SERVICE BULLETIN

Classification: HA99-004b	Reference: NTB99-071b	Date: April 4, 2001
------------------------------	--------------------------	------------------------

NISSAN BLOWER MOTOR NOISE - COVER INSTALLATION

Figure 1

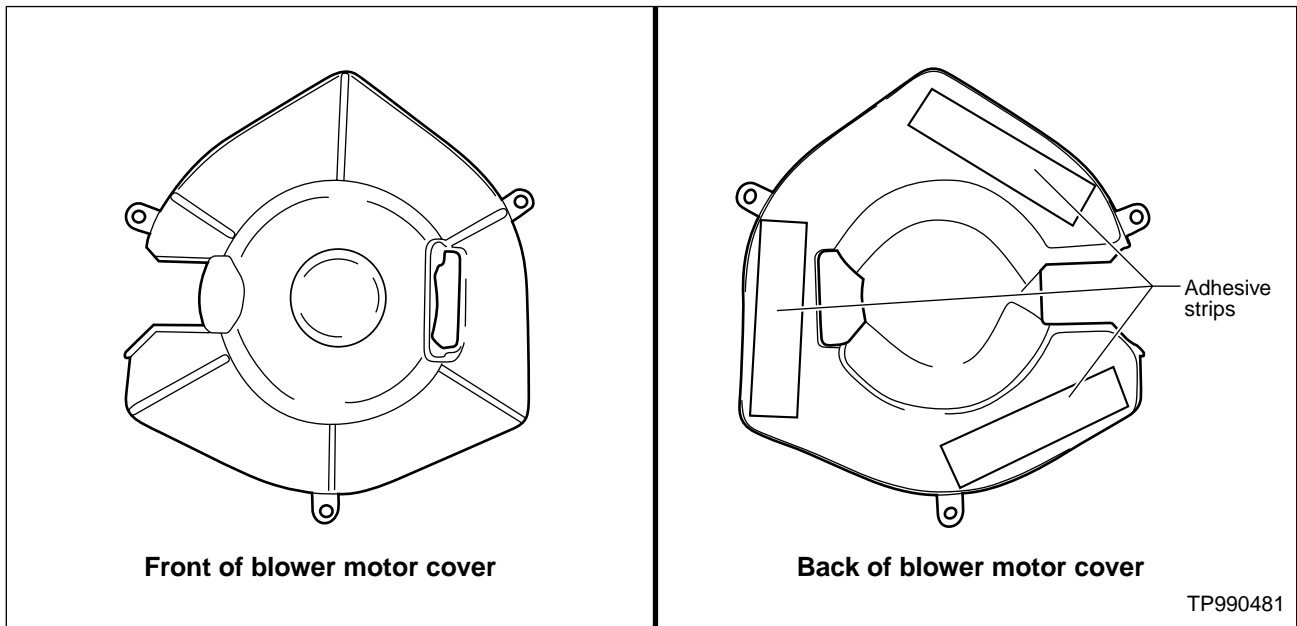
If a customer indicates that a light ticking or humming noise can be heard coming from the blower motor of an applied vehicle when the motor is run at low fan speeds (speed 1 or 2), a new, noise reducing blower motor cover is available (see Figure 1). The noise, if it occurs, may be very slight and, at times, difficult to hear.

4. Peel the protective coverings from the adhesive strips on the blower motor cover (see Figure 1 for adhesive strip locations).

Figure 2

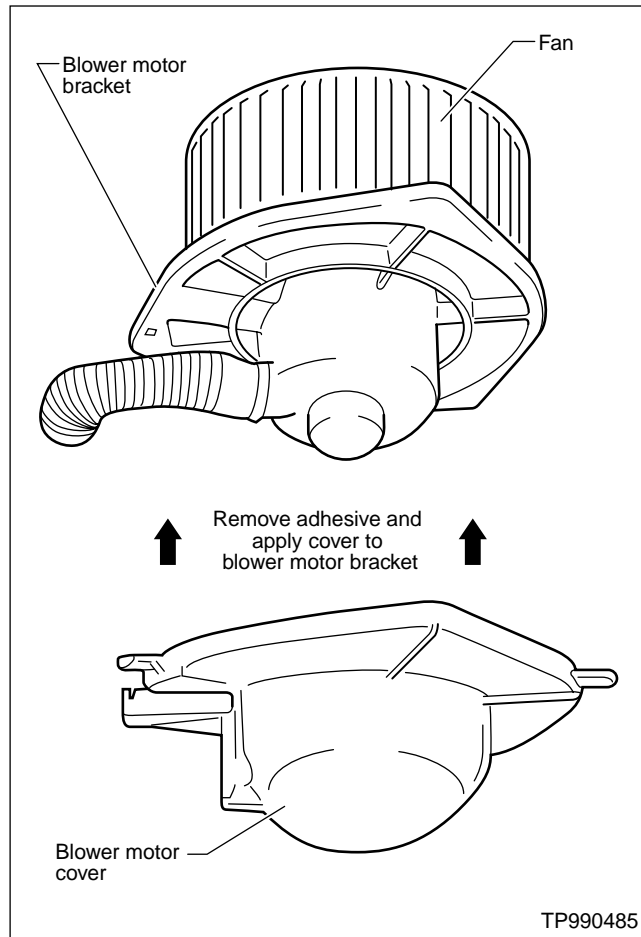
5. Install the blower motor cover onto the motor bracket (see Figure 2).
